REPUBLIC AVIATION CORPORATION
FARMINGDALE, LONG ISLAND, NEW YORK
SERVICE DEPARTMENT

OPTIONAL CHANGE

SERVICE BULLETIN NO. 17

INSTALLATION STEERABLE TAIL WHEEL

Figure 1
Yoke Rework

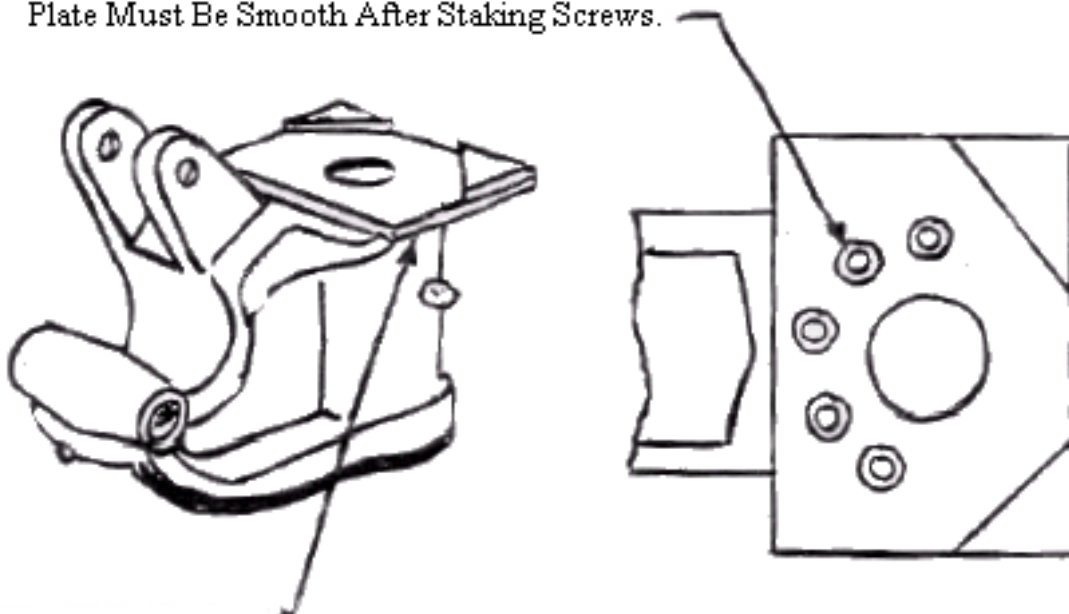
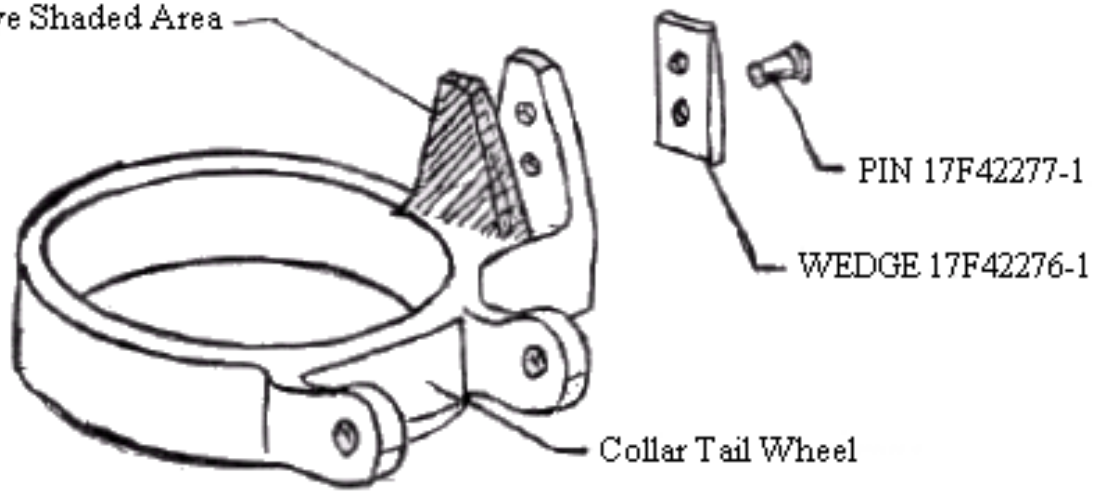
1. Rework the yoke assembly in accordance with Figure 1. It will be noted that this rework consists of removing the top portion of the yoke, which was previously used to support the lock pin aft pulley. It is suggested that this material be removed with a hacksaw and then file smooth to existing flat counterbore. Be sure to cover needle bearings to prevent chips, etc. from getting on them.

2. Place Cam Assembly 17F42180-1 on top of yoke so that center of holes in cam and yoke line up within +.005 inches. Using pilot holes in cam as guides drill five holes #26 (.147) 3/4 inch deep into yoke enlarging pilot holes in cam at same time. Tap holes in yoke and cam #10-24-5/8 inch deep (NC-2). Countersink holes on top of cam .372 inch diameter by 82°. Attach cam to yoke using five AN505C10-8 screws. Stake these screws in place. The top surface of the cam plate must be smooth after staking the screws. Refer to Figure 1.

NOTE:
REMOVE SHADED AREA TO EXISTING FLAT SURFACE AS SHOWN

Drill #26 (.147) -3/4" Deep in Yoke and Cam - Tap #10-24-5/8" Deep (NC-2)
Countersink .372" Dia x 82°. 5 Holes Equal Spaces as Shown.
AN 505-C10-8 Screws (5) Stake in Place - Surface of Cam.
Plate Must Be Smooth After Staking Screws.

CAM ASSEMBLY ON YOKE

CAM ASSEMBLY ATTACHMENT

Figure 2
Collar Rework

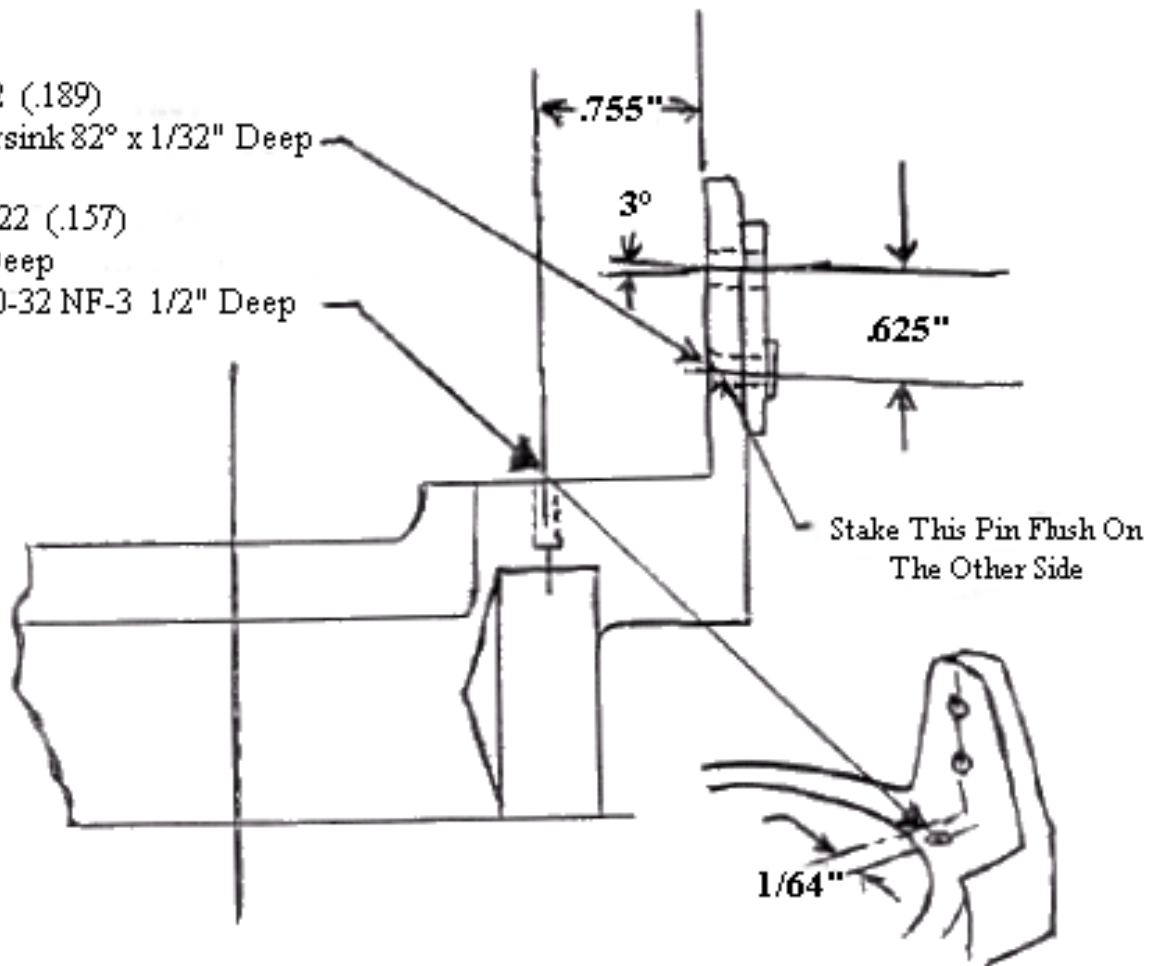
1. Rework aft shock absorber collar in accordance with Figure 2. This work can be accomplished with collar in place. This rework consists of removing the inboard ear on the collar. This ear may be removed with a hacksaw and filing smooth. Also note that a #22 (.157) 5/8 inch deep hole must be drilled and tapped #10-32-1/2 inch deep (NF-3) into side of collar.
2. Place Wedge 17F42276-1 on outboard side of ear on collar as shown in Figure 2 so that centers of pilot hole in wedge and hole in ear line up. Using full size #12 (.189) hole in wedge as guide drill #12 (.189) through ear on collar. Countersink

hole on inboard side of ear 82° by 1/32 inch deep as shown. Attach wedge to ear with 17F42277-1 pin, staking pin on inboard side and filing smooth if necessary. Using pilot hole in wedge as guide drill and ream ¼” (.250) through wedge and ear normal (perpendicular) to outboard surface of wedge.

Remove Shaded Area

Drill #12 (.189)

Countersink 82° x 1/32" Deep

Drill #22 (.157)

5/8" Deep

Tap 10-32 NF-3 1/2" Deep

Figure 5

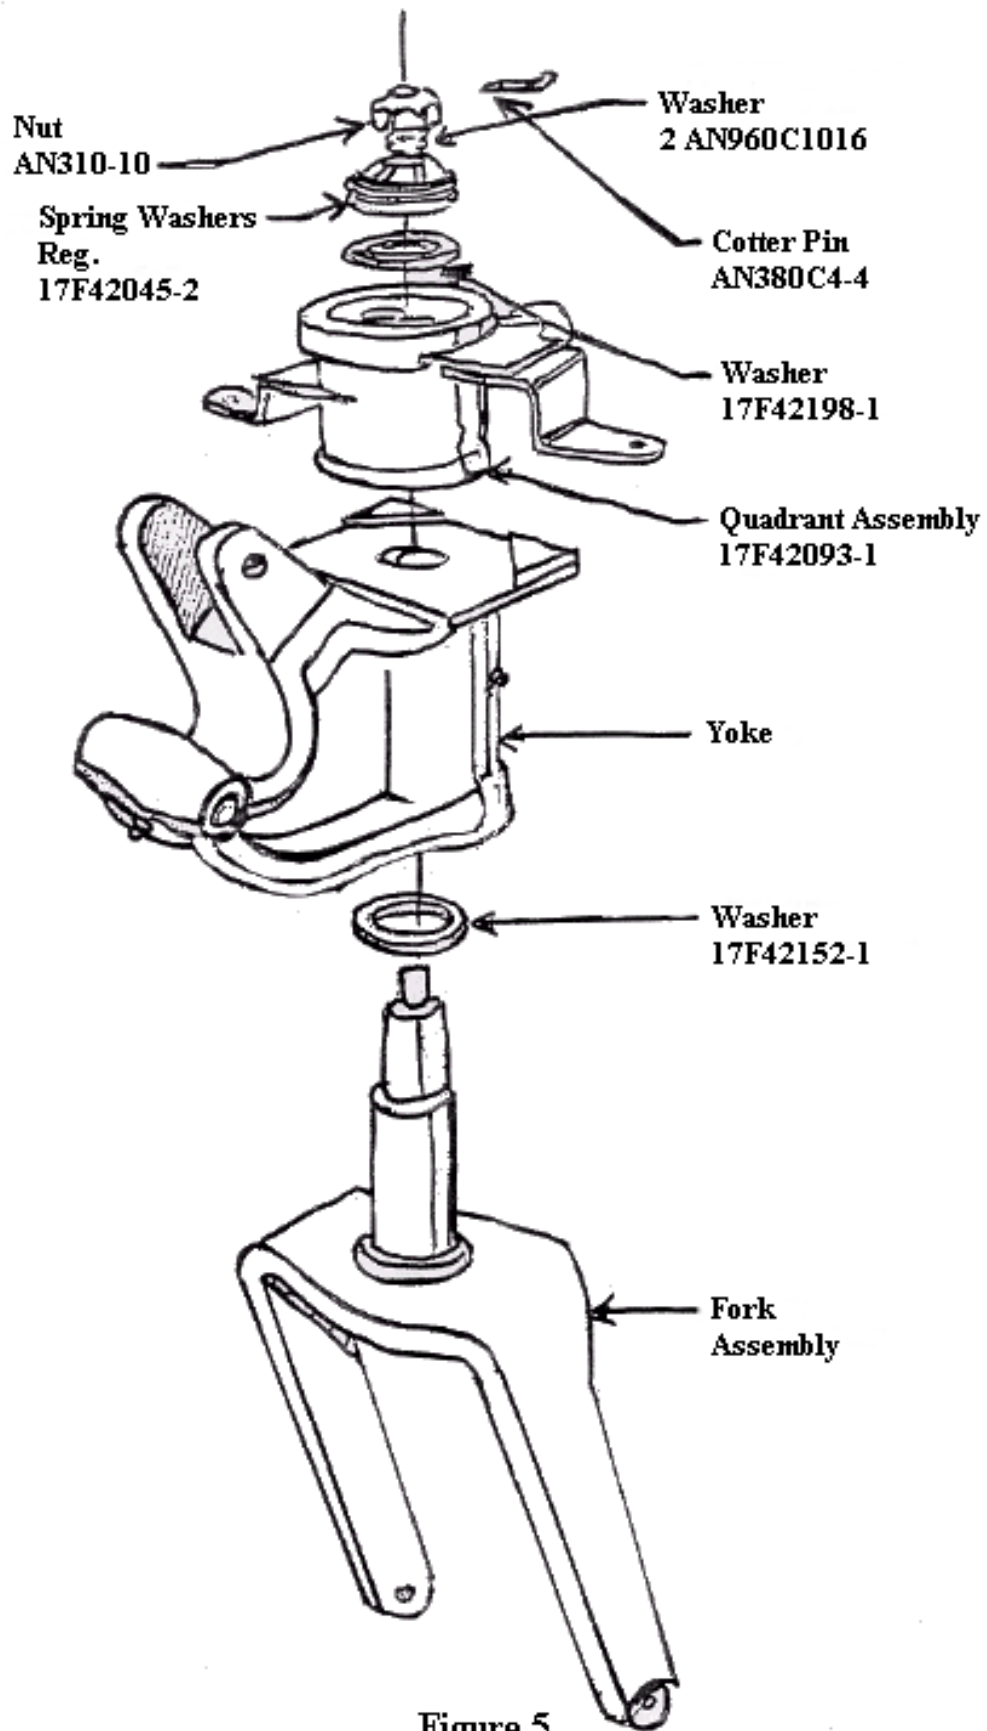
1. Referring to Figure 5 assemble yoke and quadrant assemblies on Fork and Spindle assemblies as follows:
 - a. Place 17F42152-1 washer over spindle.
 - b. Place yoke assembly over spindle.
 - c. Place Quadrant Assembly 17F42093-1 with Bushing Assembly 17F42175-1 over spindle.
 - d. Place Washer 17F42198-1 over spindle.
 - e. Place two Spring Washers 17F42045-2 over spindle.
 - f. Fasten assembly together with two AN960-C1016 washers, one AN310-10 nut and AN380-C4-4 cotter pin tightening nut sufficiently to resist a 20# to 25# side load applied at the bottom of the fork.
 - g. Apply AN-G-15 or equivalent waterproof grease at lubricating fittings on yoke.
 - h. Assembly old wheel, tire, etc. on this assembly.

Figure 7

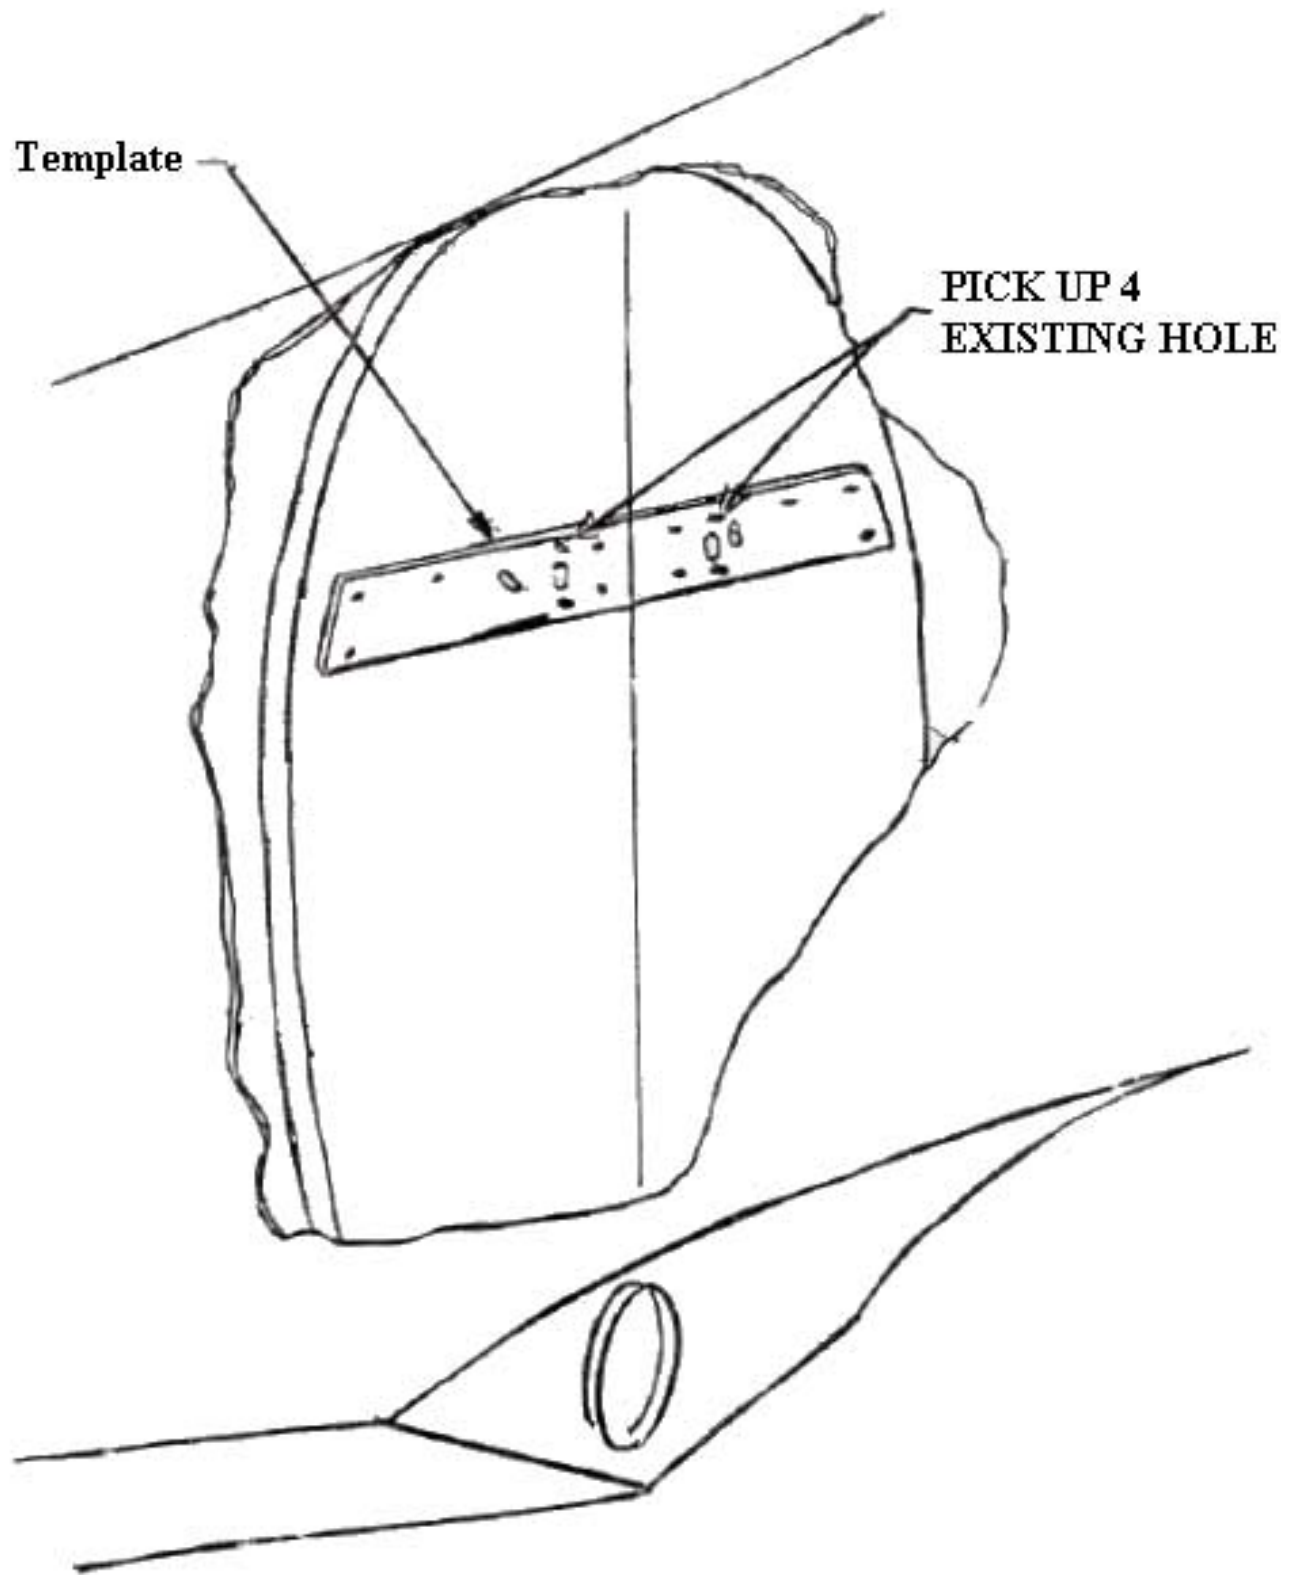
4. Place drilling template in place on aft side of bulkhead Station 230.5 referring to Figure 7 holding it in place with four bolts at existing fairlead holes and drill ten #10 (.194) holes through diameter holes through bulkhead using elongated holes in template as guides. Use a rotary or rat-tail file to open these holes up to full elongated size. Remove template.

Figure 8

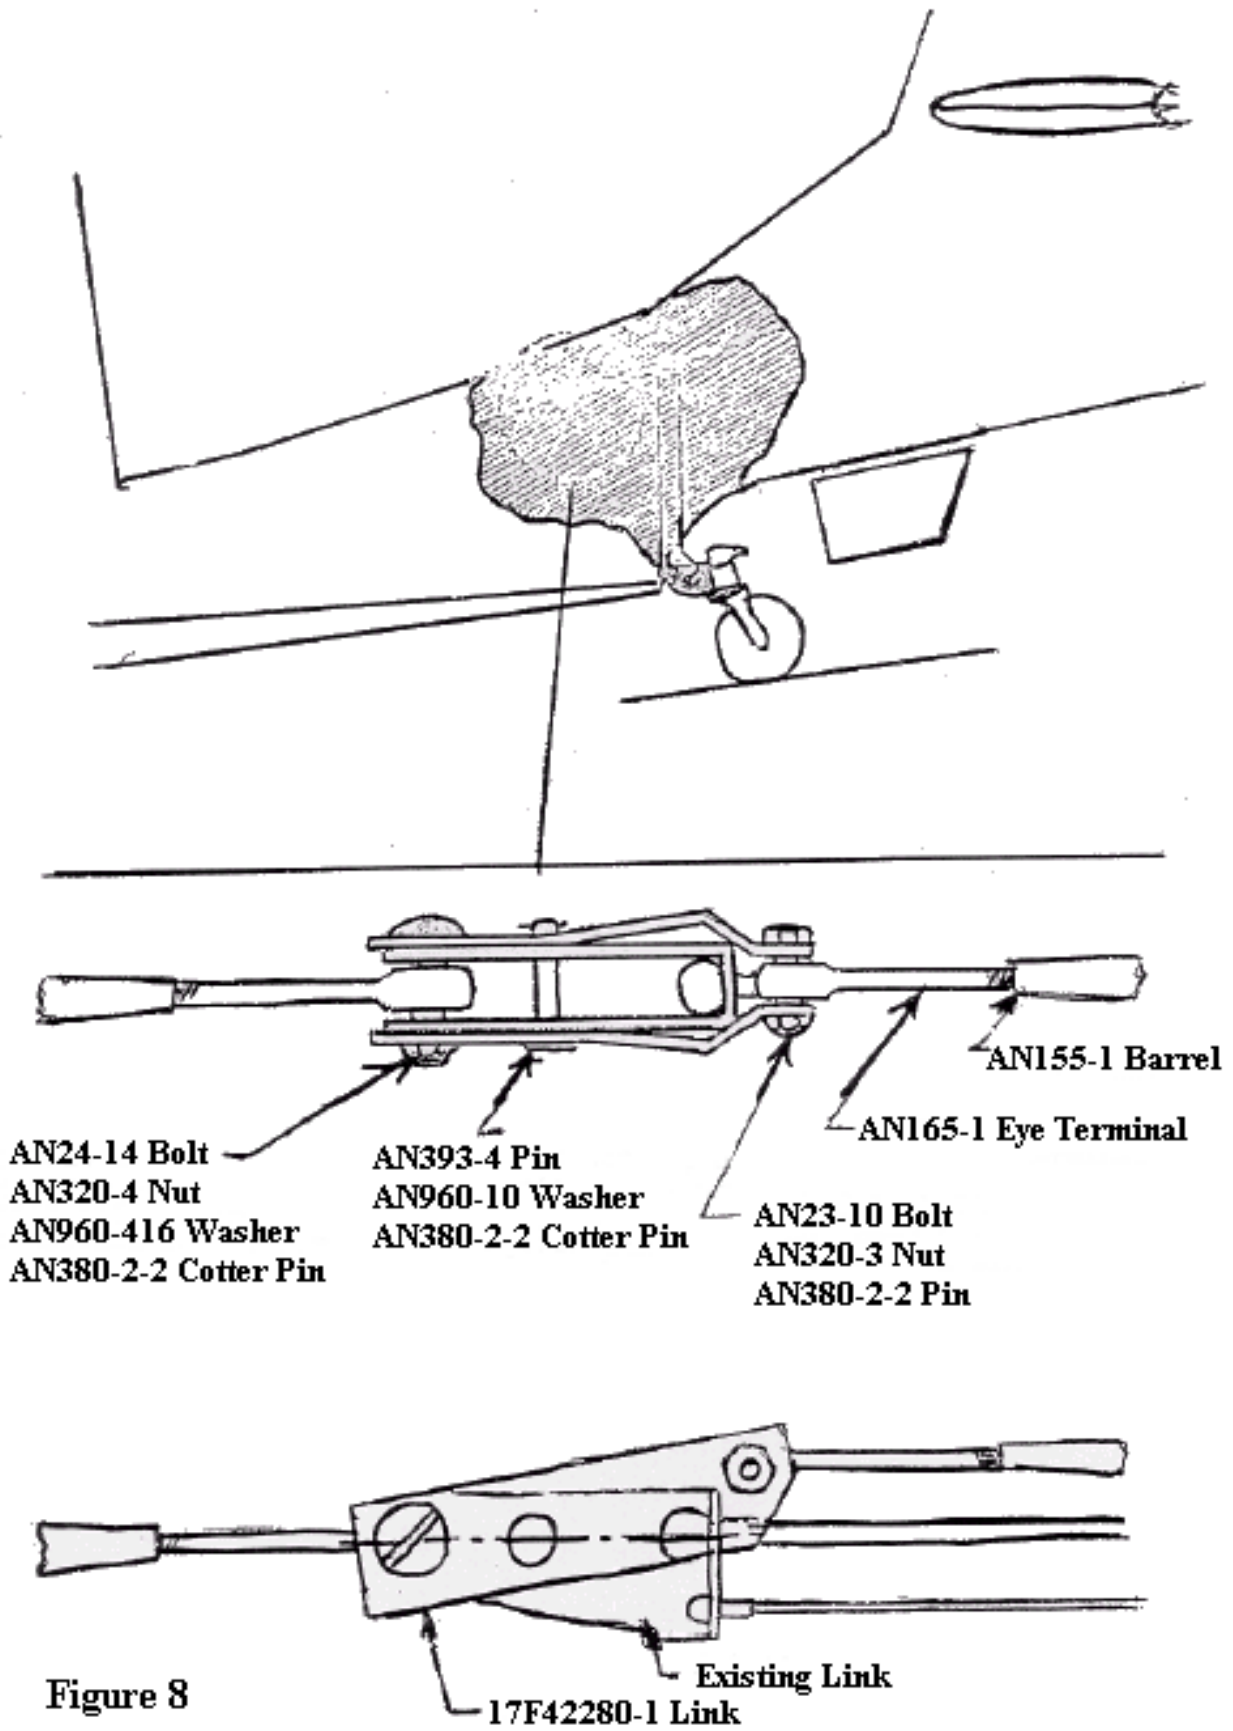
3. Disconnect rudder and water rudder control cables at rudder cross tubes in cabin. Then remove bolts holding cables to link at point shown on Figure 8. Pass aft cables through bulkhead Station 230.5. This will necessitate removal of the fairlead at this point.

- bracket assembly to bulkhead with ten AN3-4A bolts, AN365-1032 nuts and AN960-10 washers.
6. Clamp a left and right Link 17M42280-1 on either side of original links as shown on Figure 8 and drill #12 (.189) holes through original links using holes in new link as guides. Fasten new links to old links with AN393-21 pin, AN960-10 washer and AN380-2-2 cotter pin.

8. Reinstall reworked links as shown in Figure 8 using AN24-14 bolt, AN320-4 nut and AN960-416 washer and AN380-2-2 cotter pin for each link. Reconnect cables at crosstube in cabin.

9. Attach each forward end of new steerable tail wheel control cables to links using an AN155-16L barrel, AN165-16L eye terminal, AN23-10 bolt, AN320-3 nut and AN380-2-2 cotter pin. Refer to Figure 8.
